Service Bulletin

Subject:	Bulletin No:	01-047/04
NEW ENGINE OIL LEVEL GAUGE (DIPSTICK) - SERVICE TIP		
	Last Issued:	12/21/2004

2005 RX-8 - With VINs after JM1FE*****143676

NEW OIL LEVEL GAUGE

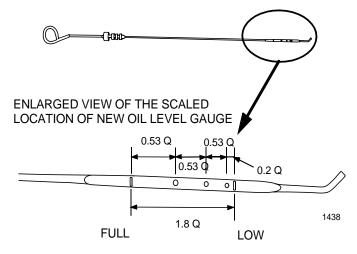
The following changes have been carried out on RX-8's oil level gauge (dipstick).

- The material has been hardened.
- The diameter of the dipstick has been decreased from 0.12" (3.0 mm) to 0.08" (2.0 mm).
- · Dotted marks have been added to the oil level indicator.
- There is no longer a chamfer on the tip.

This service information is to inform you how to read the dotted marks on the new dipstick. These changes are also outlined in the Owner's Manual (Maintenance and Care section).
